**REVIEW TYPE:** Preliminary Plan Revision

**APPLYING FOR:** Parking Lot Expansion

**PROJECT NAME:** Evangelical Lutheran Church of the Redeemer

**CASE #:** 1-96007R

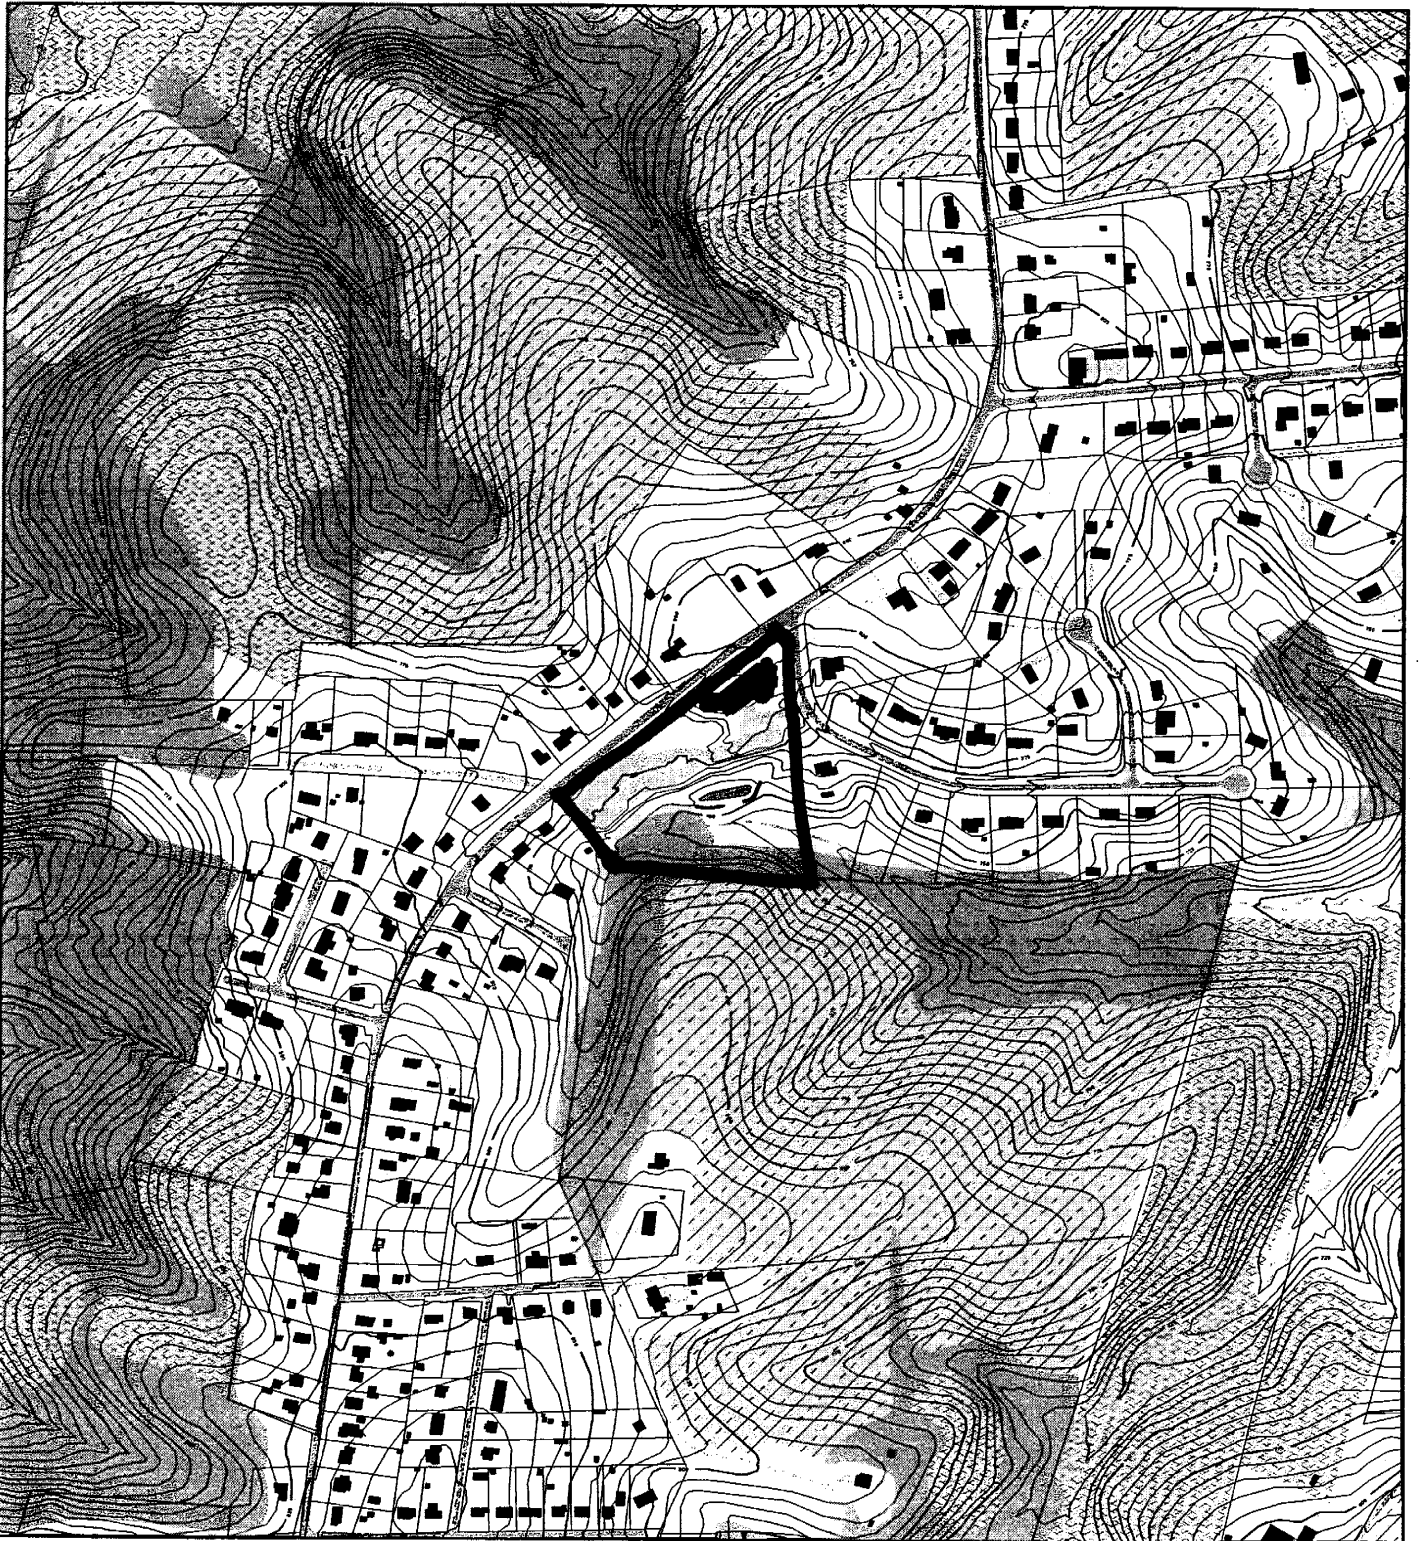
Staff recommends denial of the applicant's request to increase the parking area on this property. Being in the transition zone of the PMA, this property should not exceed 10 percent imperviousness. The existing and approved future improvements already exceed this level by a considerable amount. Waivers of the PMA requirements may be granted for existing, non-conforming uses, but staff believes that this site has already

Staff typically uses the average imperviousness level of an existing, non-conforming zone as the basis for waiver recommendations. The underlying zone on this property is RE-2C, which has an average imperviousness level of 19 percent. The 27.8 percent imperviousness that can be constructed per the approved preliminary plan for this property already significantly exceeds an average RE-2C development. Staff believes additional impervious surface on this site is unacceptable and would contribute to degradation of stream water quality in the subwatershed and watershed in which the property is located.

Staff is also opposed to additional impervious surface on this property because it would be located completely in the designated stream buffer for the on-site stream. The stormwater management facility currently located in this buffer existed prior to the review and approval of the preliminary plan. While it is undesirable because it prevents the preferred use of the buffer for forest establishment, it is not impervious and provides better stormwater quality and quantity control than the alternative underground facility would. Provision of best possible stormwater management and use of other best management practices are typically required to offset the negative impacts of exceeding the recommended 10 percent PMA imperviousness level. Since the property already exceeds this level, the existing stormwater management facility should be retained. Staff believes adequate consideration of the need for on-site parking has already been given as part of the approved preliminary plan which permitted stream buffer encroachment for some of the previously requested new parking lot.

Finally, staff is opposed to additional loss of existing forest within the stream valley, which would result from adding parking to this site. The forest protected in the stream valley was the major consideration for granting approval of the buffer encroachment needed for existing parking. A considerable amount of this forest is now being cleared because of the master plan required extension of Woodfield Road through this property. Mitigation for this road clearing will be provided by the County in the Patuxent watershed, but not in the subwatershed of the stream being affected. Because the overall percentage of forest in the subwatershed is not high, it is important to maximize forest retention where possible.
